**PLANNED UNIT DEVELOPMENT
& SUBDIVISION STAFF REPORT**

Date: May 15, 2008

DEVELOPMENT NAME I-65 East Service Road Development Subdivision

CONTEMPLATED USE Planned Unit Development Approval to allow multiple buildings on a single building site, with shared access between two building sites, and Subdivision approval to create 2 lots.

SUBDIVISION DETAIL

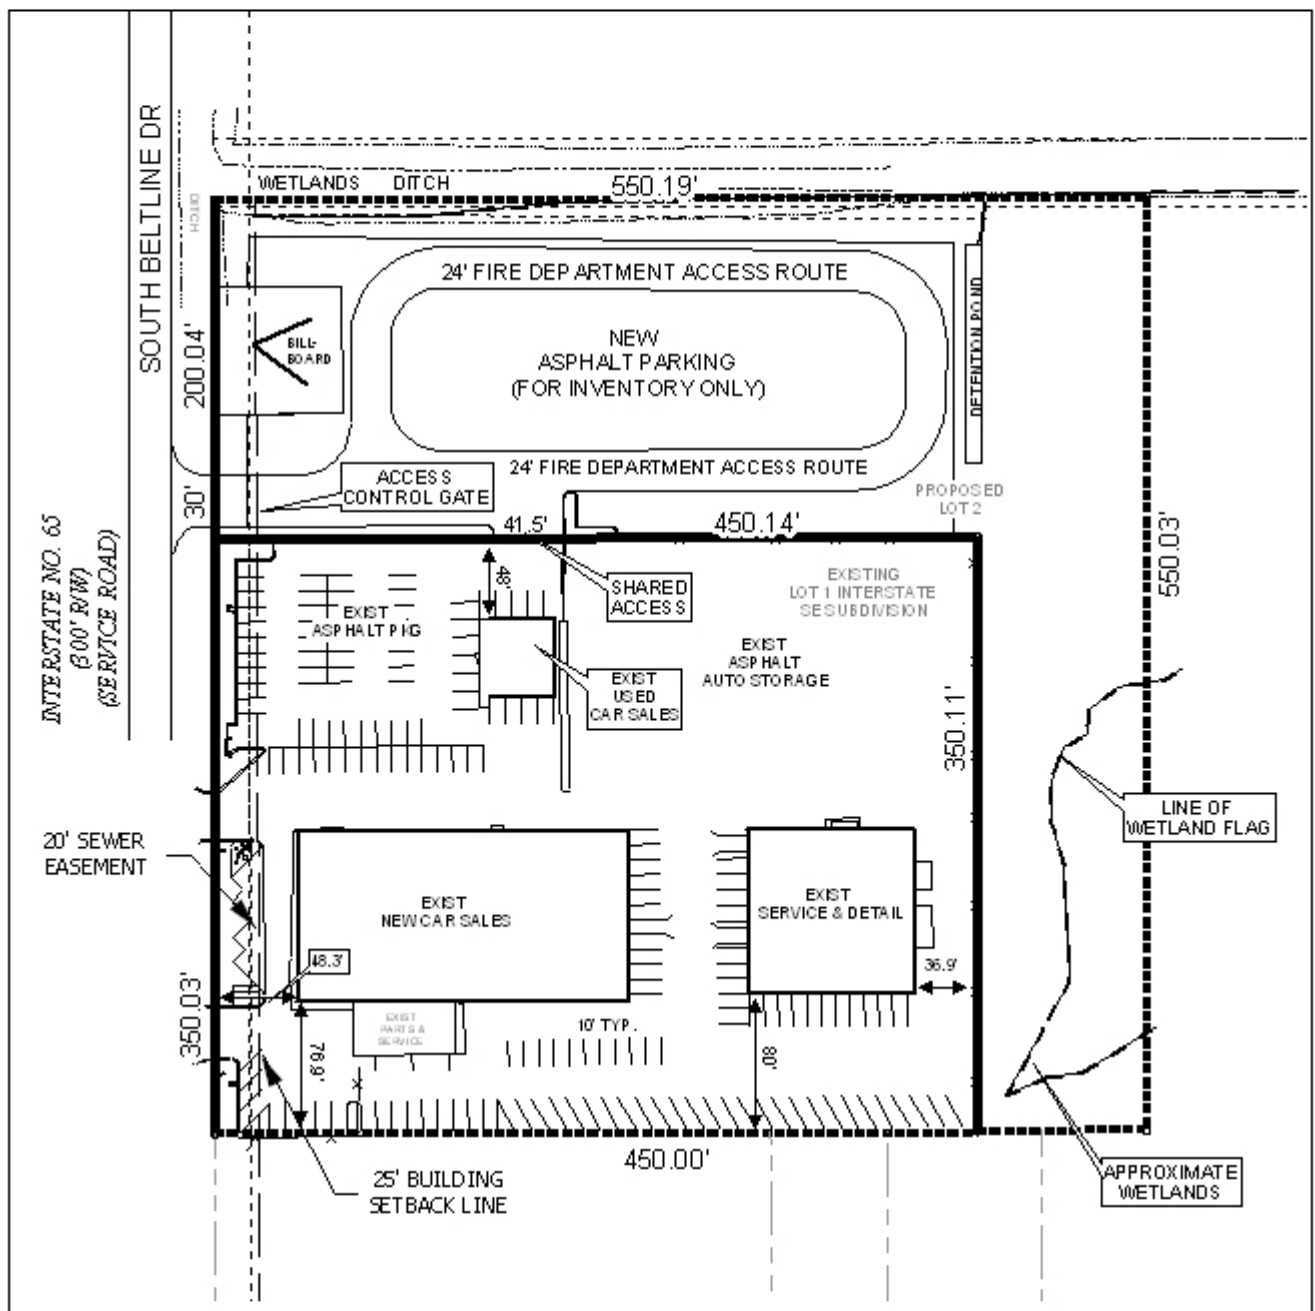
The 25-foot minimum building setback line is not depicted on the Subdivision plat or the PUD site plan, but is required. Both drawings should be revised to depict the setback line from all public and private streets.

Much of the Subdivision site appears to contain wetlands, as identified by available National Wetlands Inventory data, and some wetland areas are delineated on the PUD site plan, but not on the Subdivision plat: wetlands should be delineated on both the site plan and the plat. The potential presence of wetlands indicate that the area may be environmentally sensitive; therefore, the approval of all applicable federal, state and local agencies would be required prior to the issuance of any permits or land disturbance activities.

- 5) Delineation of wetlands on the final plat, if any, and the approval of all applicable federal, state and local agencies regarding wetlands prior to the issuance of any permits or land disturbance activities;

- 7) Revision of the Subdivision plat and PUD site plan to depict a 25-foot minimum building setback line from all public and private streets;
 - 8) Provision of a revised PUD site plan;
